Feedback coefficient constraints

(comment #205)

Adam Healey

April 2021 (r0)

Backplane and cable (TP0-TP5) channels

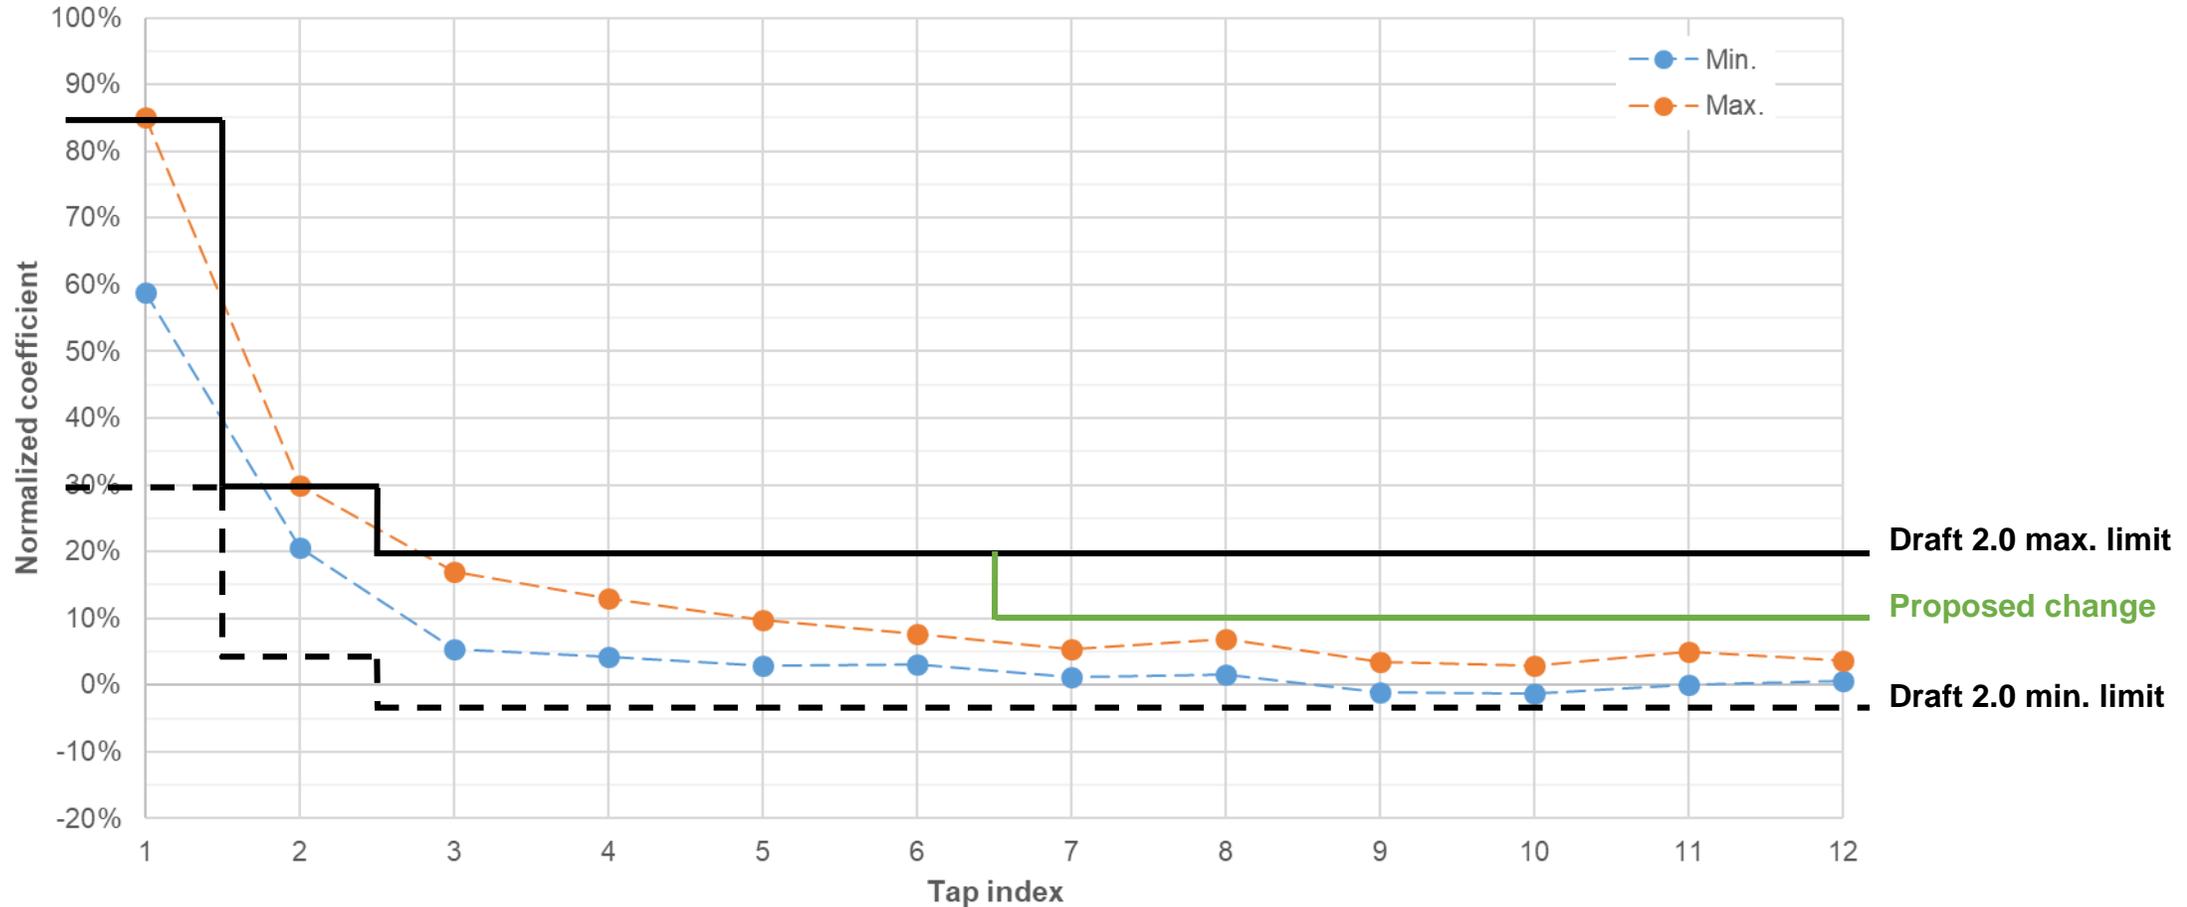
- In Clauses 162 and 163, reference receiver feedback coefficient $b(n)$ is allowed to have a maximum value of 0.2 for $n = 3$ to 12
- Channels observed to meet minimum Channel Operating Margin (COM) requirements produce much smaller values for later coefficients
- The constraint may have initially been set for sake of simplicity, but more complicated constraints have since been added
 - Separate lower and upper limits
 - Separate limits for $n = 1, 2,$ and $3 \dots N_b$
- Limit for larger n should be tightened so that unexpected channels have more difficulty satisfying the COM limit
- Consider the coefficient profiles for models and measurements provided to the [Task Force](#)

101 channels with COM \geq 2.5 dB, 2 tests (package transmission line length) per channel, 202 coefficient sets

- Propose the following changes to Table 162–18 and Table 163–10

Parameter	Symbol	Value	Units
Normalized DFE coefficient maximum limit for $n = 1$ for $n = 2$ for $n = 3$ to $6N_b$ <u>for $n = 7$ to N_b</u>	$bb_{\max}(n)$	0.85 0.3 0.2 <u>0.1</u>	—
